Development Review Board

Tuesday, December 19, 2023, 5:00 PM

ZAP-23-12; 123 King Street (RH, Ward 5) Rebecca Keinath / Charles Keinath

ZP-23-530; 0 University Road (I, Ward 1) University of Vermont / State Agricultural College / Claire Forbes

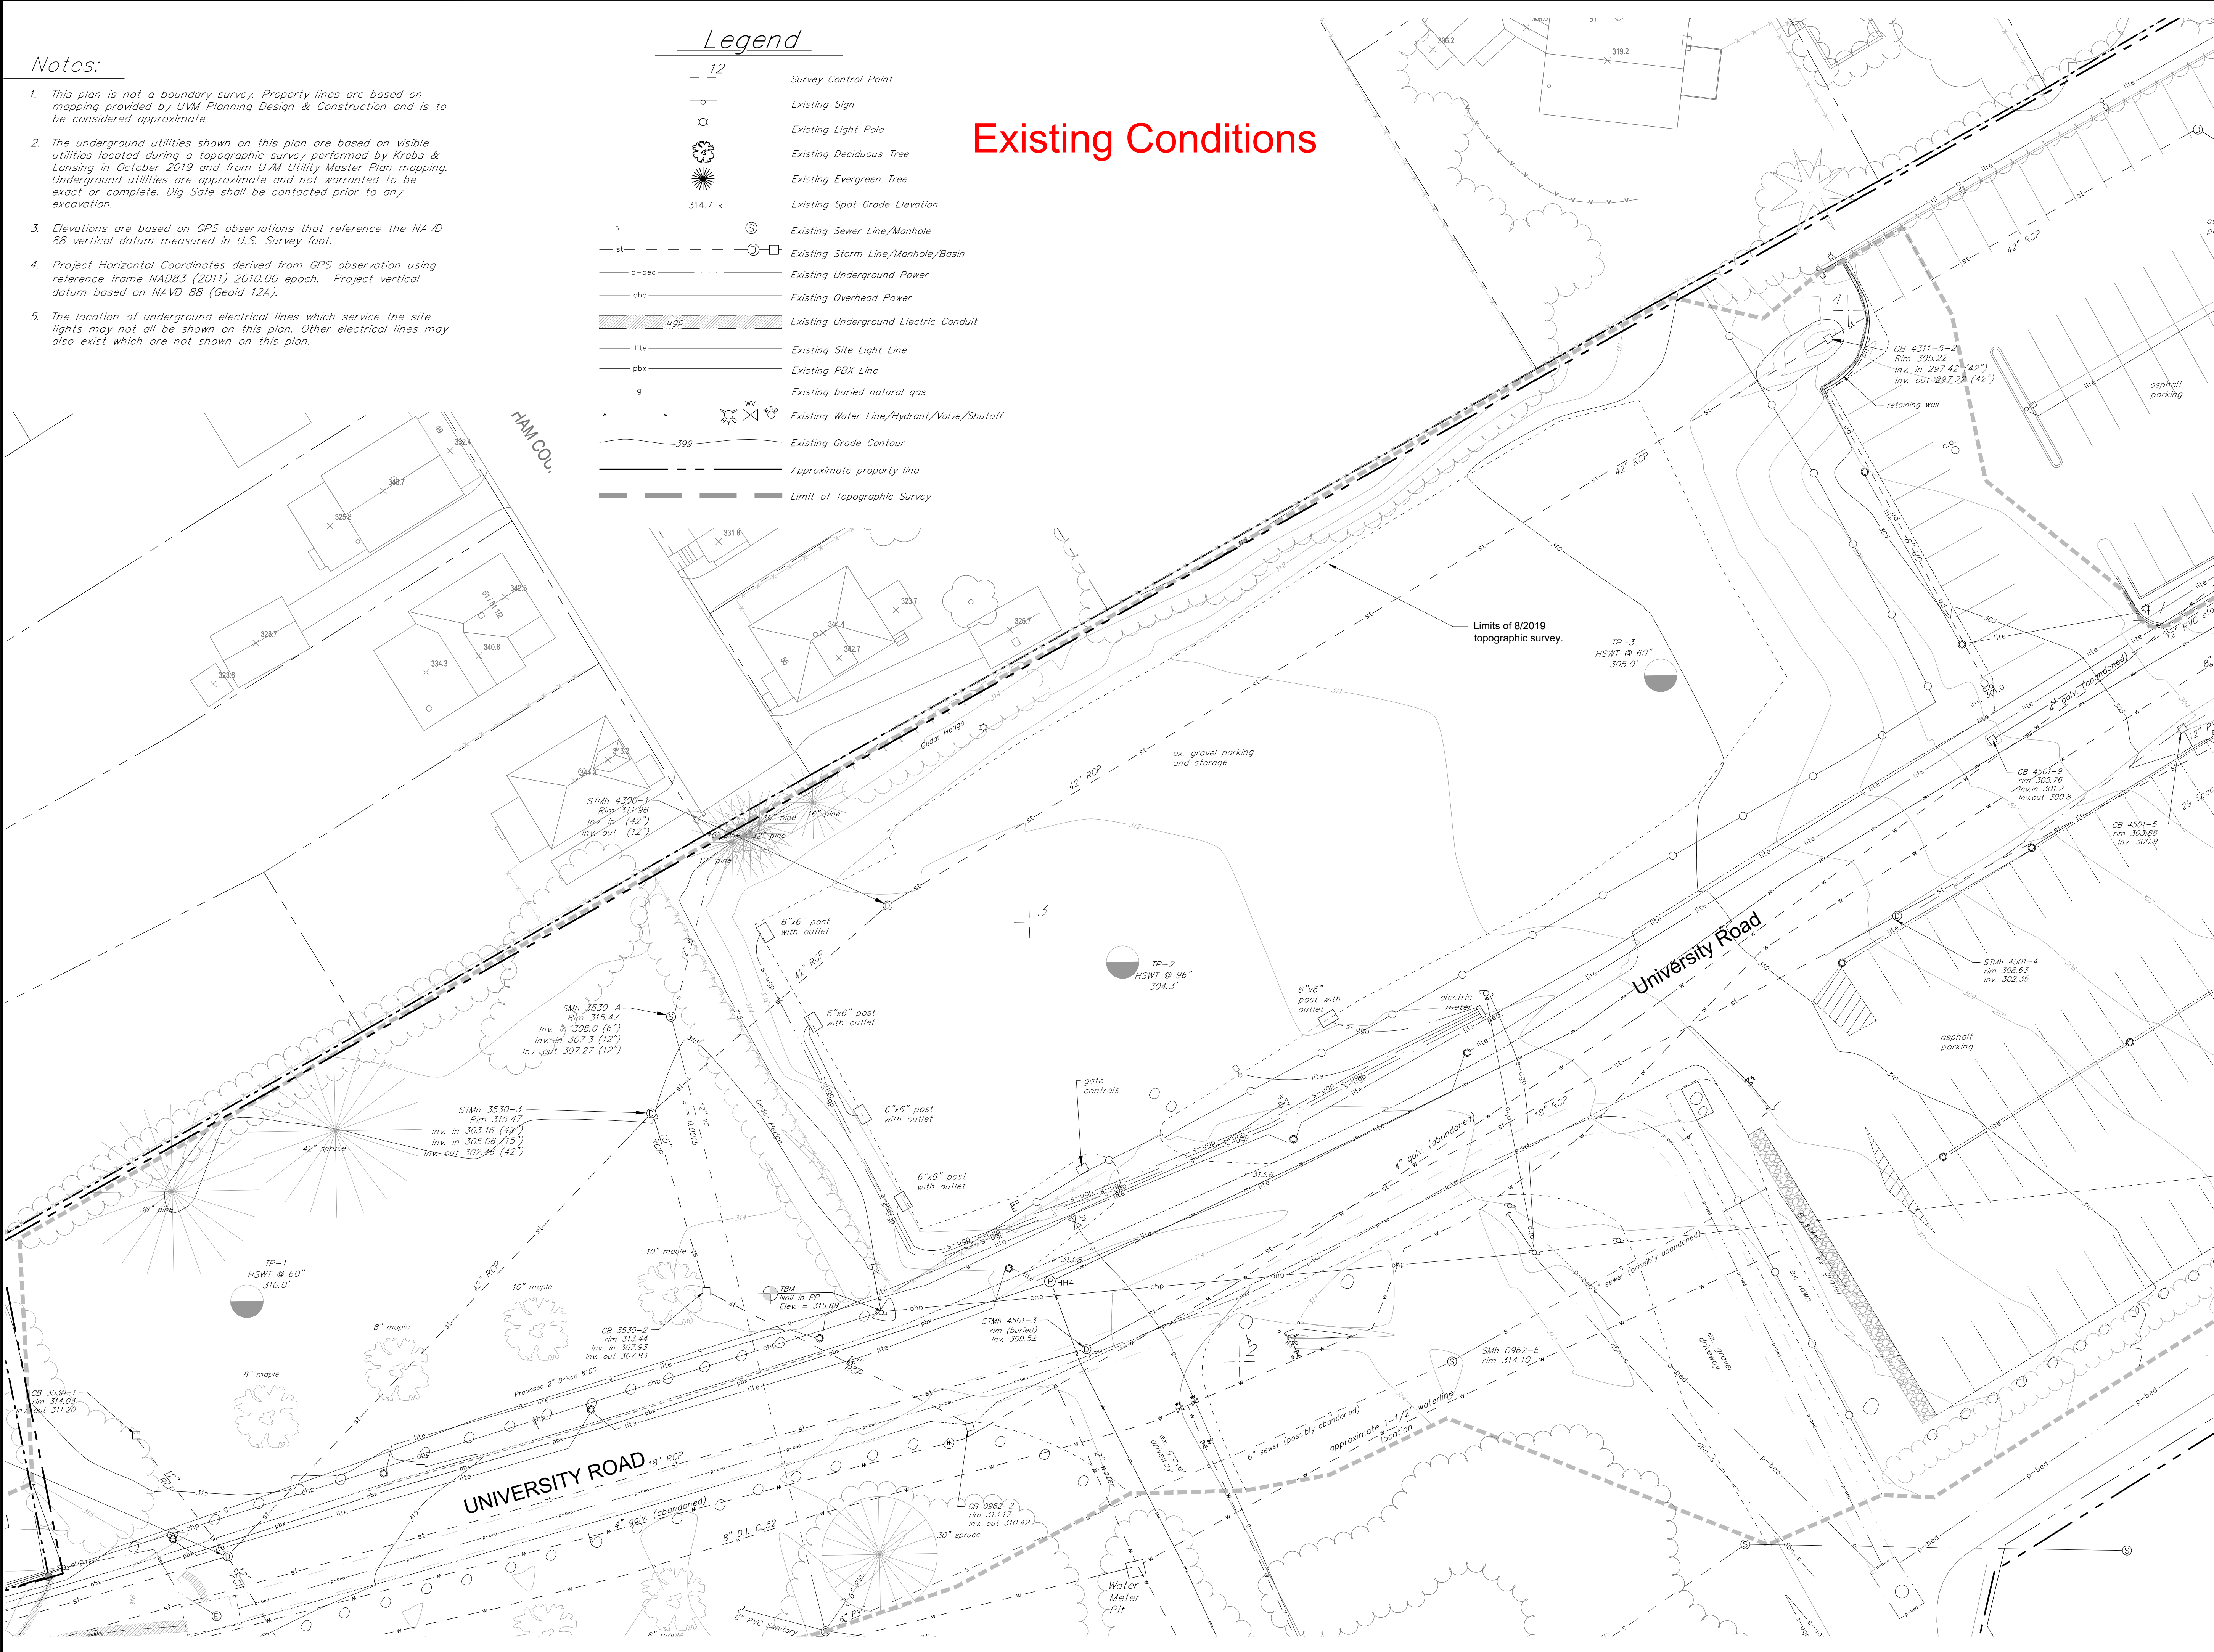
RL-CENTENNIAL SPORTS PARCEL WILL INCREASE LOT COVERAGE FROM 82.93% TO 89.38%
